Date of Notice: (DD/MM/YYYY) **22/08/2017** Product Change Notice Number: **USB3160 B PCN 20170822**

Product Identifier: **USB3160-30-XXXX-X-C**

Drawing Revision Letter: **B** Effective from date code/batch code: **Running change**

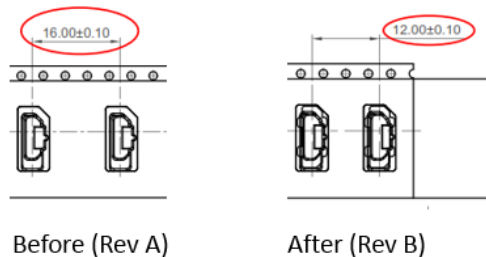
1. Change packing to vacuum bag
2. Change in reel diameter from 380mm to 330mm
3. Change packing quantity from 600pcs/reel to 500pcs/reel.
4. Change total packing quantity from 6000pcs/carton to 4500pcs/carton.
5. Change box dimensions from 405x405x330 to 355x355x305
6. Change in carrier pitch from  $16.00\pm 0.10$  to  $12.00\pm 0.10$ mm:
